date: February 29, 2024
to: Jennifer Hofmeister-Drew, AICP, LCAM, Planner III,
Town of Palm Beach
from: Eric Czerniejewski, P.E., ENV SP
subject: Paramount Palm Beach Traffic Review

MEMORANDUM

The Corradino Group, Inc (Corradino) has been requested to provide a traffic review of the Traffic Impact Evaluation for the redevelopment of the Paramount Theatre located at 139 North County Road in the Town of Palm Beach, Florida. The following are our traffic review comments based on the 02/09/24 resubmittal.

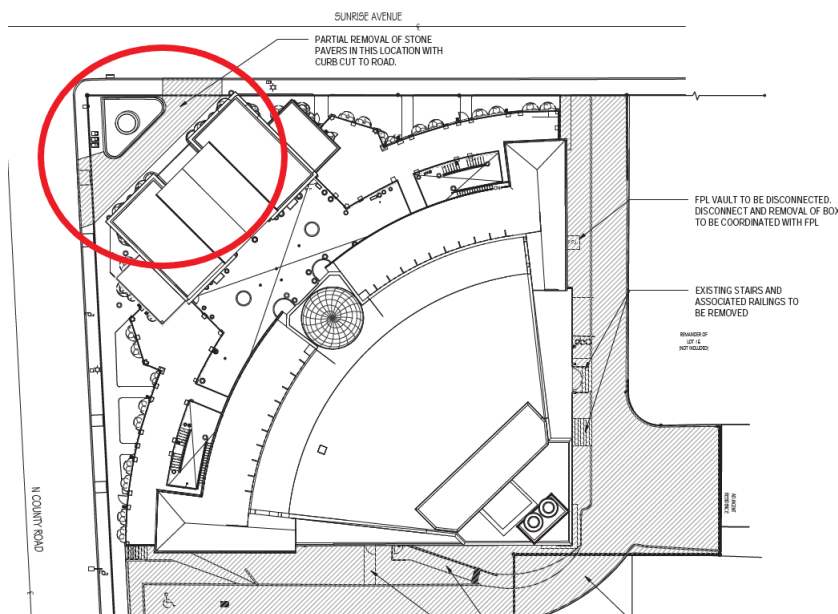
12. Please provide additional narrative that provides the total amount of queuing available from the valet stand to the adjacent road network for both scenarios. Figures 3 and 4 should be updated to denote the total amount of queuing available from the valet stand to the adjacent road network.

Kimley Horn and Associates, Inc.'s 03/09/23 Response Additional information is provided in the updated report and Figures 3 and 4 illustrating the queuing available to the adjacent road network. Note that the valet stand for the event space is proposed to be located on North County Road.

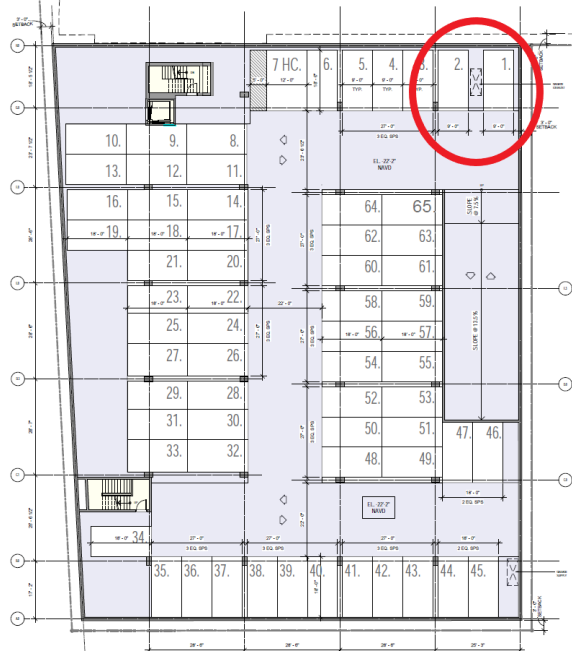
18. Please include a copy of the raw traffic counts from 11/29/22 in the Appendix of the updated traffic impact study. This traffic count data was not included as part of the traffic impact study dated 03/09/23. The Town of Palm Beach recently collected peak hour manual turning movement counts on 02/28/23 at the following three signalized intersections analyzed for the Paramount Palm Beach development:

1. Sunrise Avenue & N County Road
2. Sunset Avenue & N County Road
3. Royal Poinciana Way & N County Road

Please cross check the intersection capacity analysis completed as part of the updated traffic impact study utilizing this current traffic count data (copy of count data has been attached). Please update all tables and figures as necessary.

Kimley Horn and Associates, Inc.'s 04/18/23 Response: A copy of the raw traffic counts from 11/29/22 has been added to the Appendix. The two sets of traffic counts were compared, and there was not an overall consistent pattern between the two sets: volumes on some movements were lower, and volumes on other movements were higher when comparing the AM and PM volumes. Therefore, the Synchro analyses were not modified.

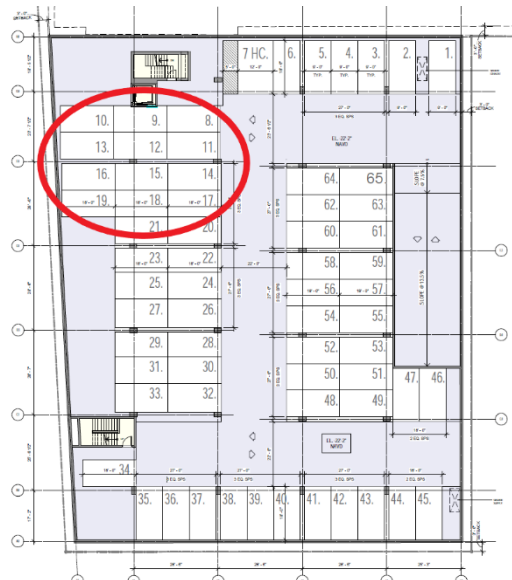
19. Please limit the number of parking spaces that are being proposed at the parking garage ramp locations to improve overall internal traffic circulation. There should be sufficient sight visibility for vehicles backing out of the proposed parking spaces for safe and efficient traffic circulation.

Kimley Horn and Associates, Inc.'s 04/18/23 Response: The architect has prepared updated garage parking plans, which have been submitted under separate cover.
